Technical Note: Planning Review of Oldlands Farm, Bognor Regis

Project: 3213 – Oldlands Farm, Bognor Regis

Date: 27 July 2021

Figure 1: Extract from FRA showing watercourse onsite.

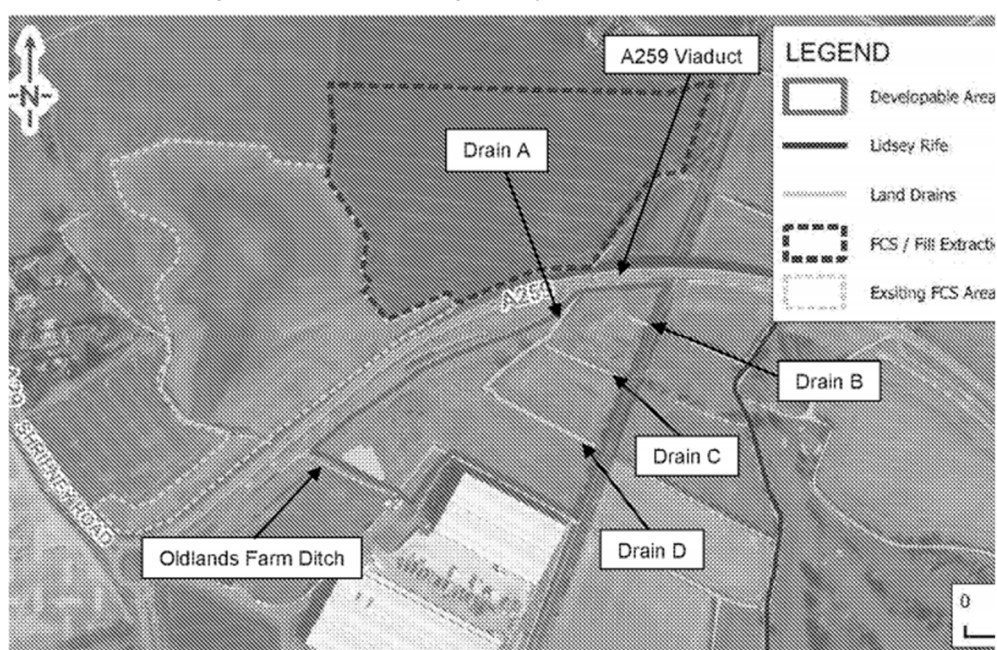
- 3.1. It is acknowledged that the Oldlands Farm Ditch (watercourse) crossing the site is intended to be culverted. However, details of the impact of these works does not appear to have been provided. It is therefore unclear what impact diverting this watercourse would have on both the site and to the wider area. Land Drainage Consent will be required separately from planning consent and whilst noted in the FRA, should be noted in the response to the Applicant.
- 3.2. The drainage strategy proposes to infill a number of existing ditches crossing the site (namely Drains A, B, C and D, as delineated on the image below), and the construction of a new watercourse running parallel to the existing railway line connected to the Oldland Farm Ditch.
